## PIC18F87J11 Family Silicon Errata and Data Sheet Clarification

The PIC18F87J11 family devices that you have received conform functionally to the current Device Data Sheet (DS39778D), except for the anomalies described in this document.

The following typographic corrections and clarifications are to be noted for the latest version of the device data sheet (DS39778D):

FIGURE 19-10: I<sup>2</sup>C™ SLAVE MODE TIMING (TRANSMISSION, 7-BIT ADDRESS)

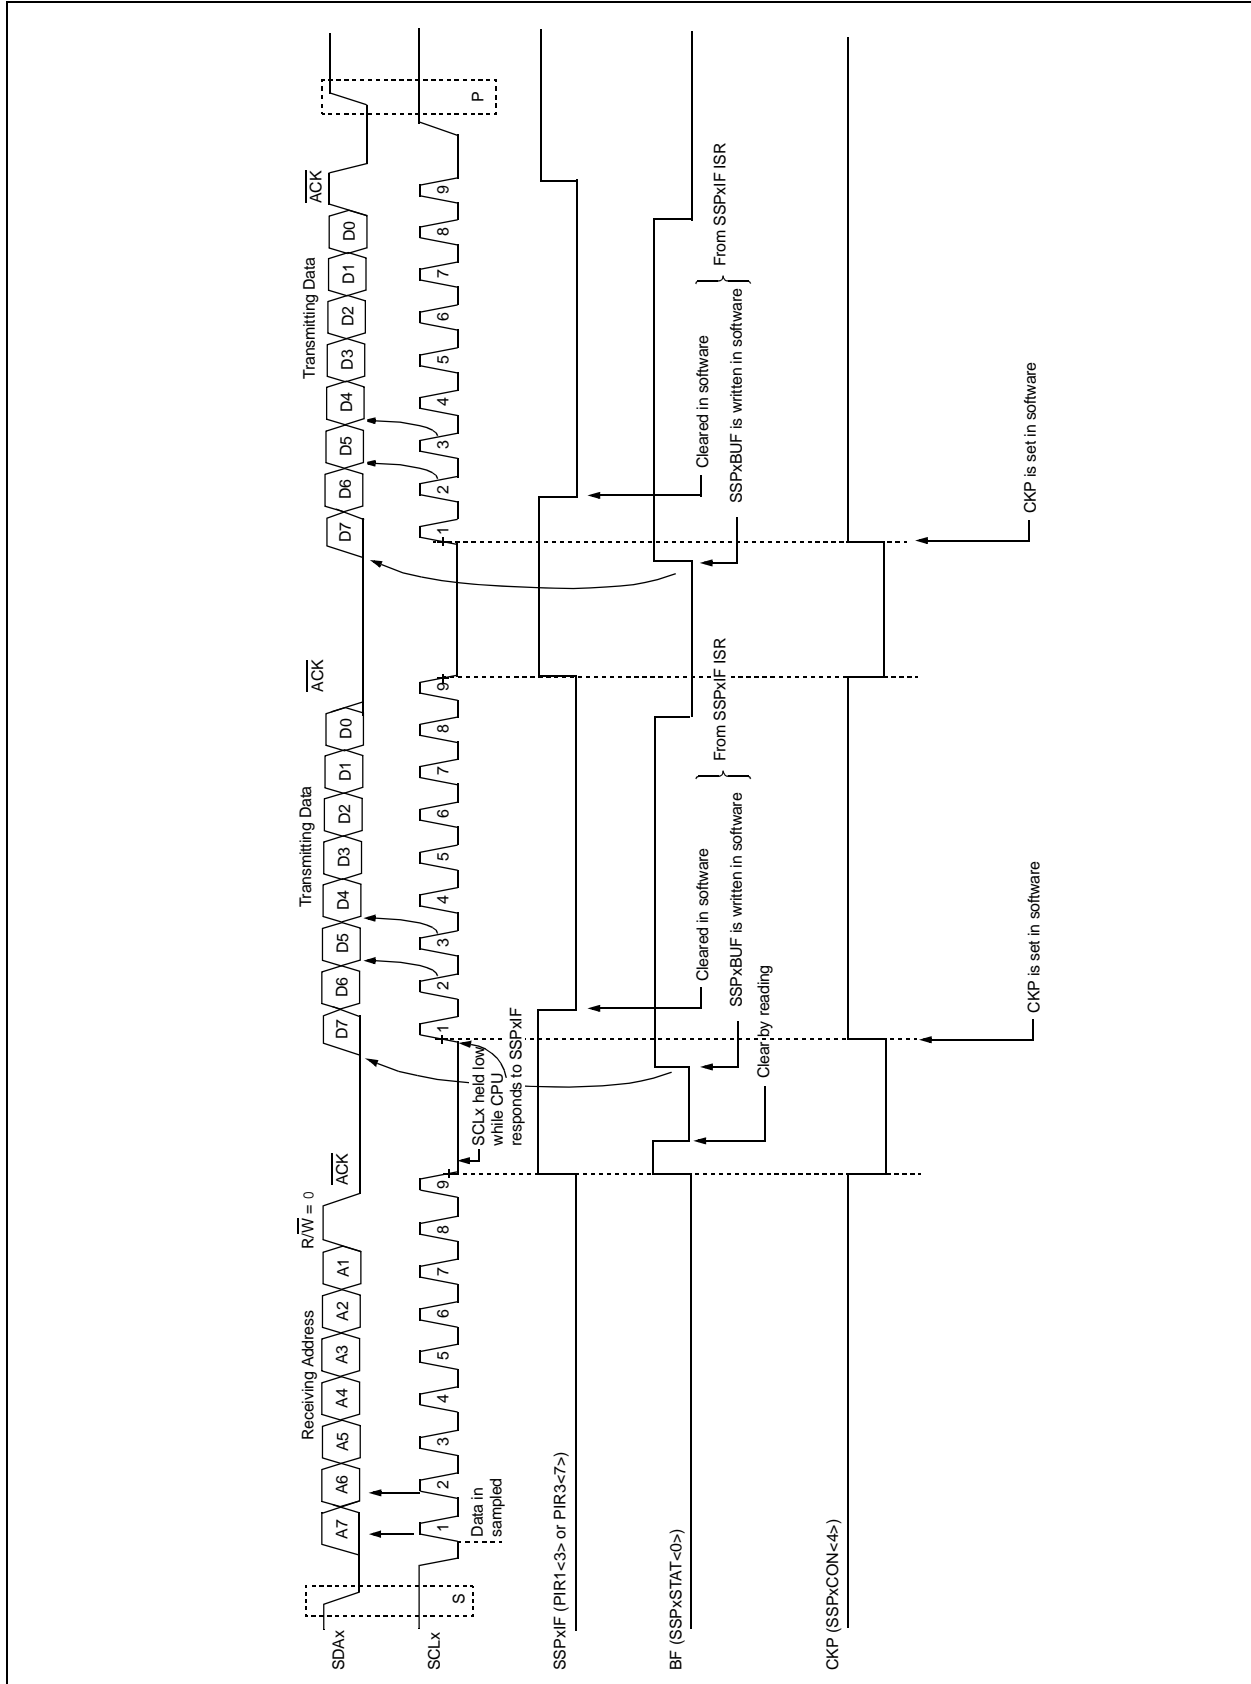
## 7. Module: Figure 19-10: I<sup>2</sup>C™ Slave Mode Timing (Transmission, 7-Bit Address)

On page 244, the figure is replaced with the new timing diagram provided in [Figure 19-10](#).

**FIGURE 19-24: I<sup>2</sup>C™ MASTER MODE WAVEFORM (RECEPTION, 7-BIT ADDRESS)**

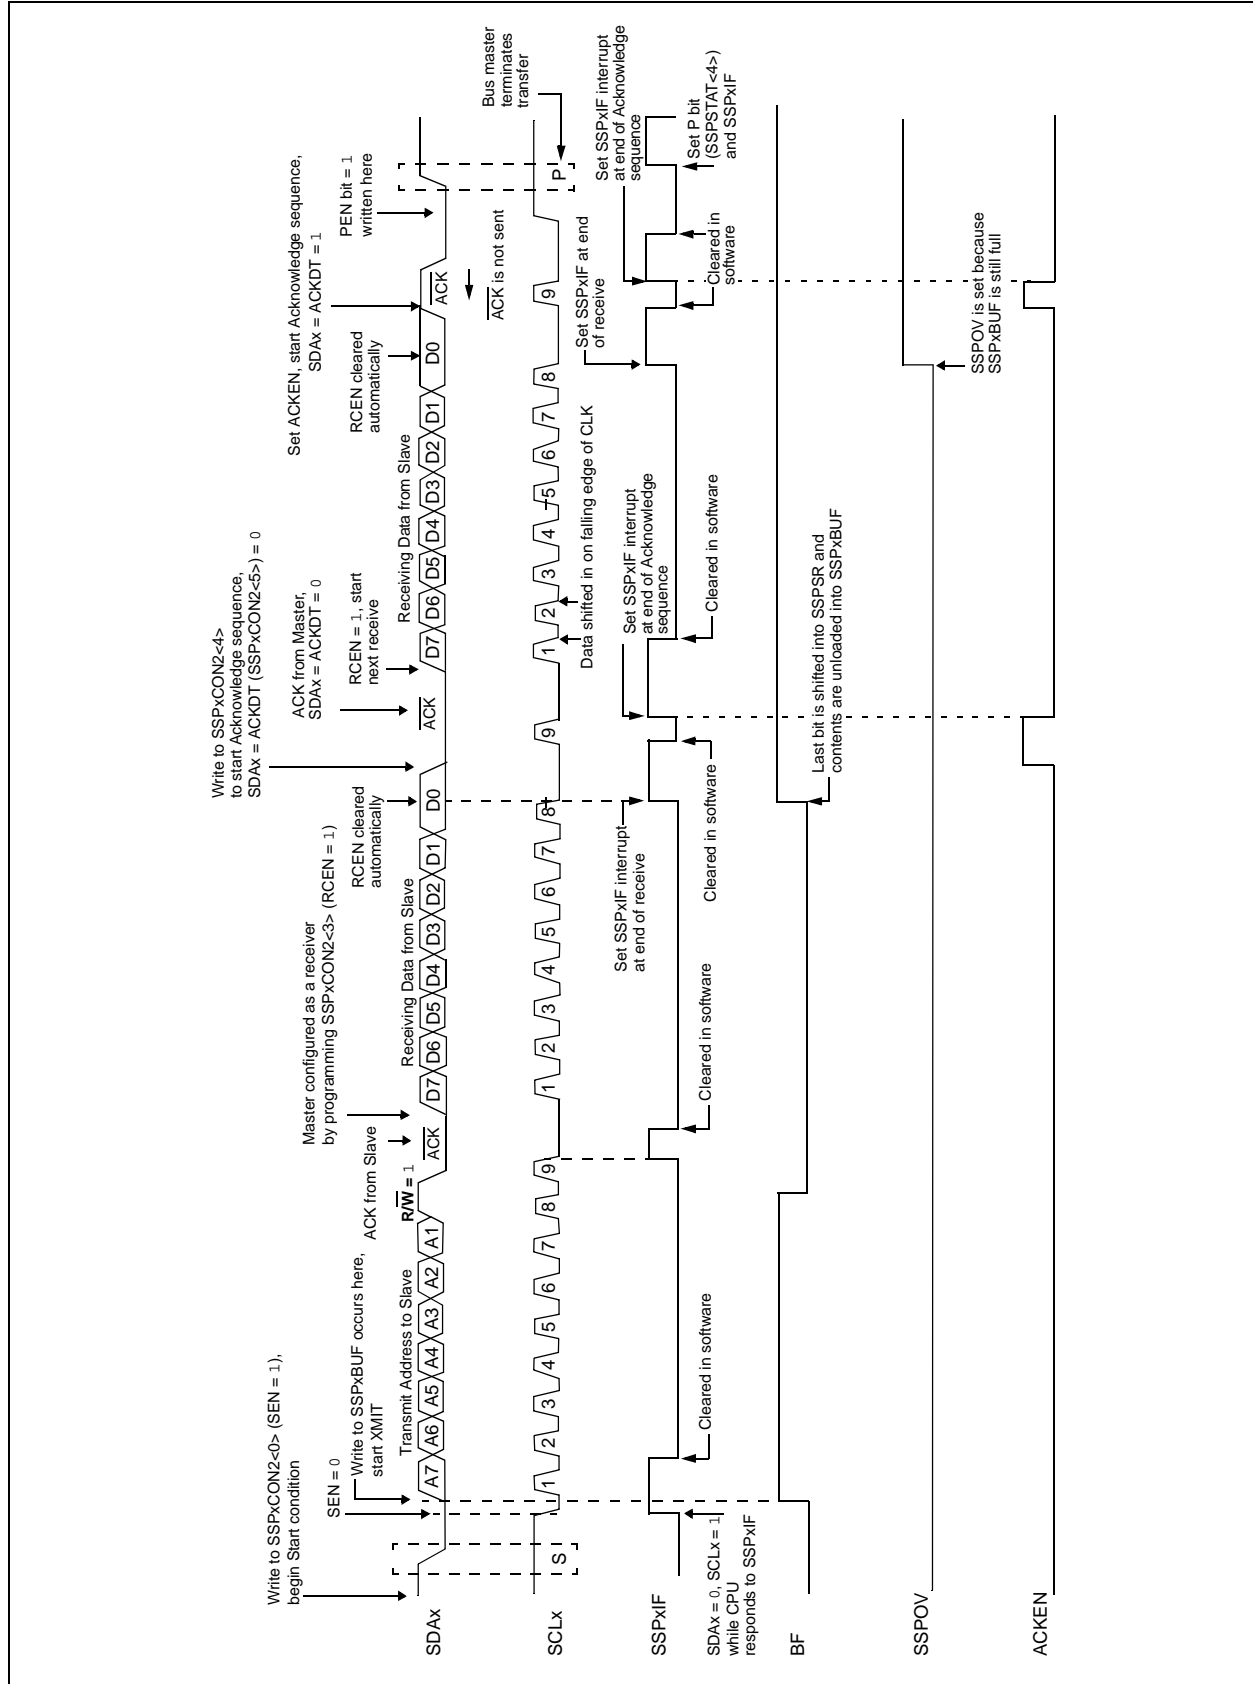
## 8. Module: Figure 19-24: I<sup>2</sup>C™ Master Mode Waveform (Reception, 7-Bit Address)

On page 261, the condition ( $R/\overline{W}$ ) when the Acknowledge signal (ACK) is received from the slave, after transmitting the address to the slave, is changed to '1'. The changed value is indicated in bold text in [Figure 19-24](#).

**FIGURE 5-7: DATA MEMORY MAP FOR PIC18F87J11 FAMILY DEVICES**

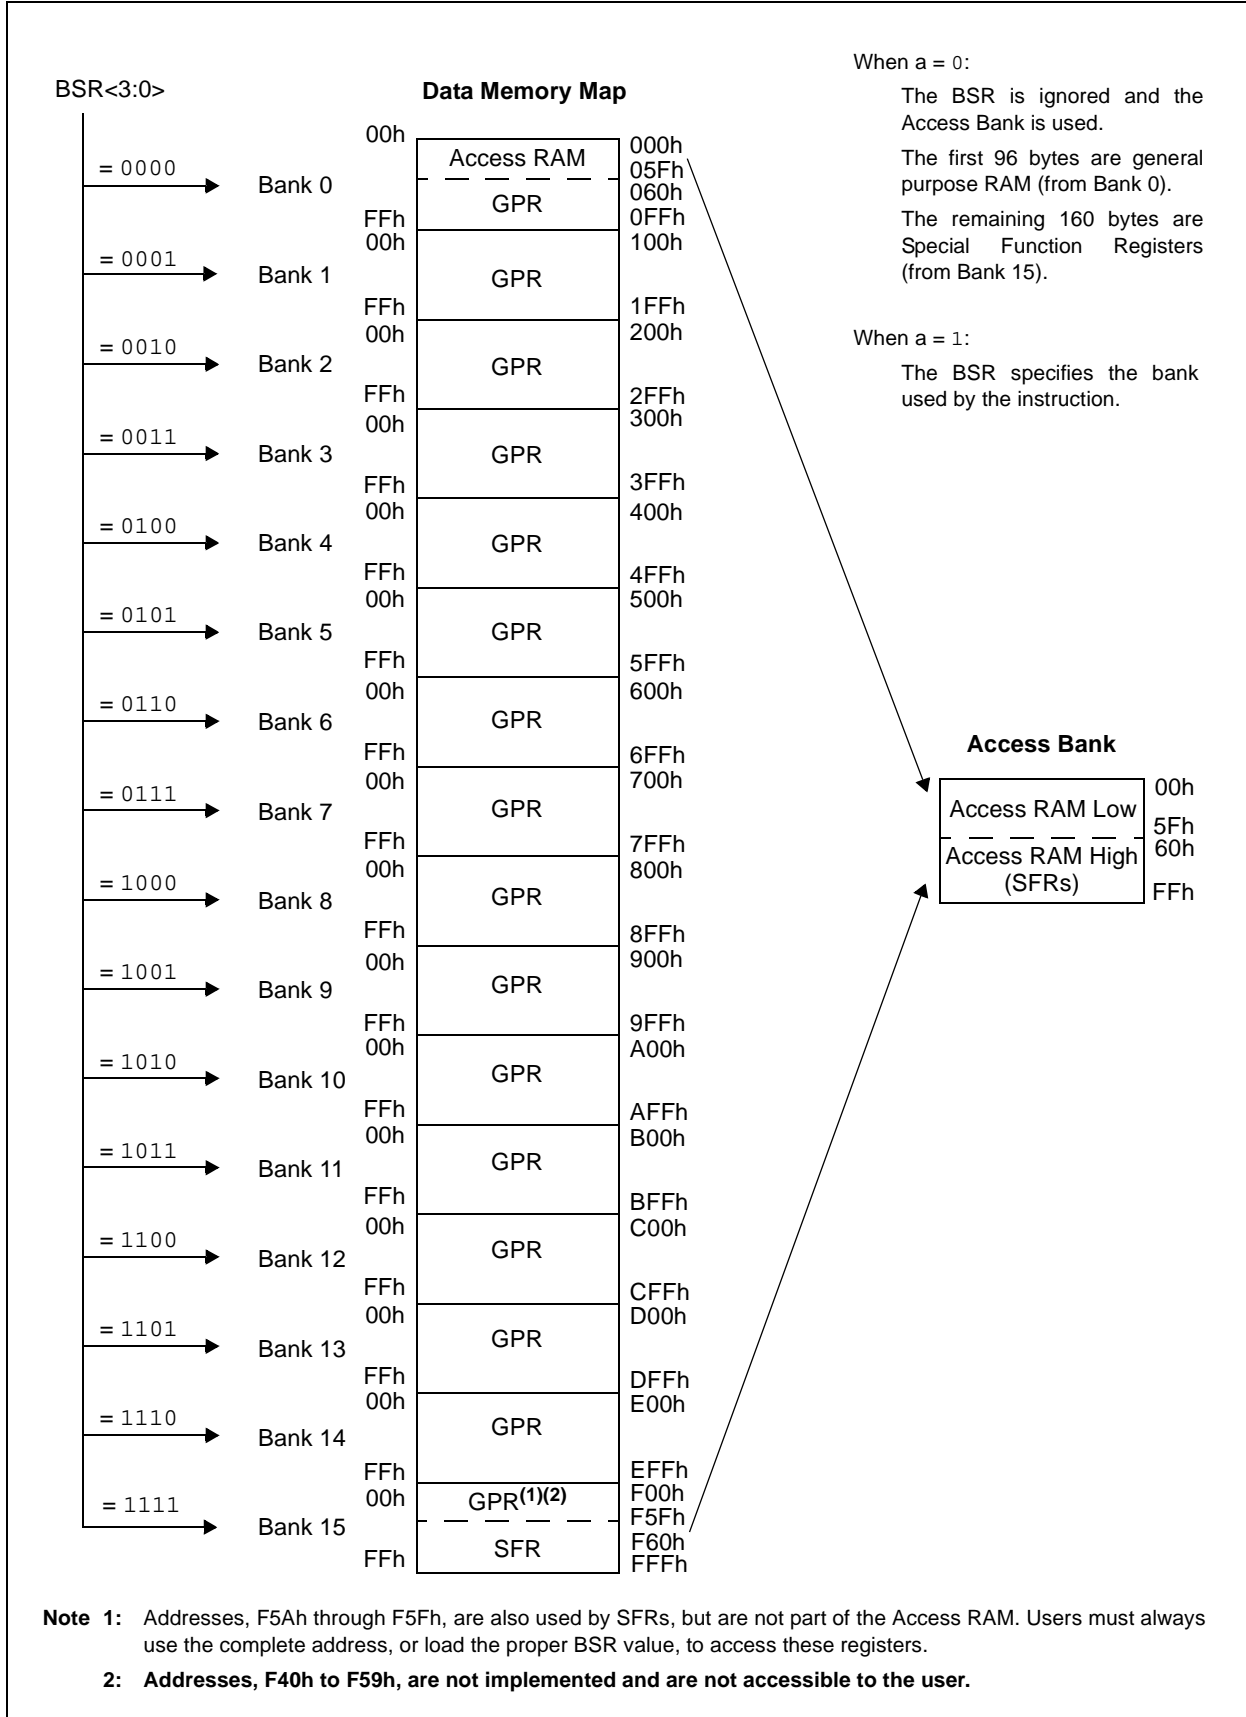
## 11. Module: Memory Organization

On page 73, in Figure 5-7, Note 2 has been added. The additional note is indicated in bold text in Figure 5-7.
